# Access Compliance Report

## Public Rights-of-Way

Intersection ID: 10037289	Main Street: SARDIS_RD_NORTH	Cross Street: N/A	Location: SE
ADA ID: F6D4546961FC	Ramp Type: Para	Initial Pass/Fail: Fail	Overall Compliance: No
Codes/Mitigation Info/Possible Solution		Field Measurements/Component Compliance	
		Severity Score: 25

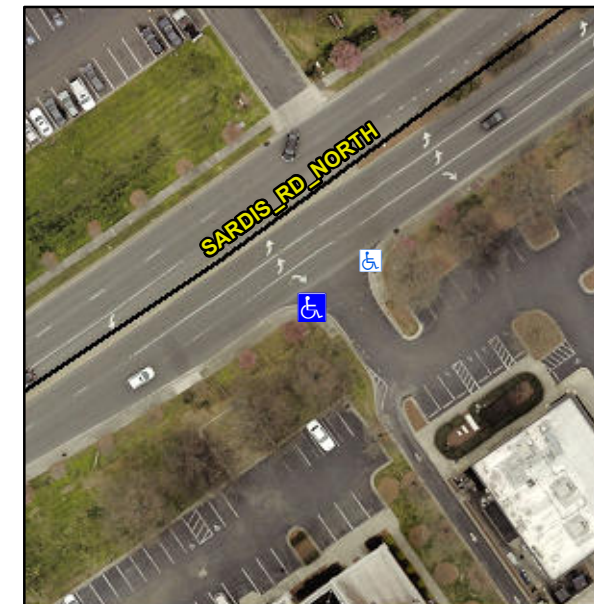
**R304.5.3, R304.3.2**

Compliance	Description	Data	Compliance	Description	Data
N/A	Ramp Length LT (in)	70.0	N/A	Ramp Length RT (in)	76.0
Yes	Ramp Width LT (in)	60.0	Yes	Ramp Width RT (in)	57.0
Yes	Ramp Slope LT (%)	7.6	No	Ramp Slope RT (%)	8.9
No	Ramp XSlope LT (%)	4.2	No	Ramp XSlope RT (%)	6.6
N/A	Landing Length (in)	N/A	N/A	DWS Provided?	N/A
N/A	Landing Width (in)	N/A	N/A	DWS Contrast?	N/A
N/A	Landing Slope (%)	N/A	N/A	DWS Length (in)	N/A
N/A	Landing X Slope (%)	N/A	N/A	DWS Full Width?	N/A
N/A	Landing Curb? (Y/N)	N/A	N/A	DWS Offset (in)	N/A
N/A	Shared Landing?	N/A			
N/A	Gutter Ponding?	N/A	N/A	Gutter Slope (%)	N/A
N/A	Gutter Lip Ht (in)	N/A	N/A	Gutter X Slope (%)	N/A
N/A	Painted X Walk1?	No	N/A	Painted X Walk2?	N/A
	X Walk 1 Direction	To NE		X Walk 2 Direction	N/A
N/A	X Walk 1 Width (in)	N/A	N/A	X Walk 2 Width (in)	N/A
	X Walk 1 Slope (%)	1.0		X Walk 2 Slope (%)	N/A
	X Walk 1 X Slope (%)	0.5		X Walk 2 X Slope (%)	N/A
N/A	Ramp inside XWalk1?	N/A	N/A	Ramp inside XWalk2?	N/A

**Remove & Replace Entire Ramp.**
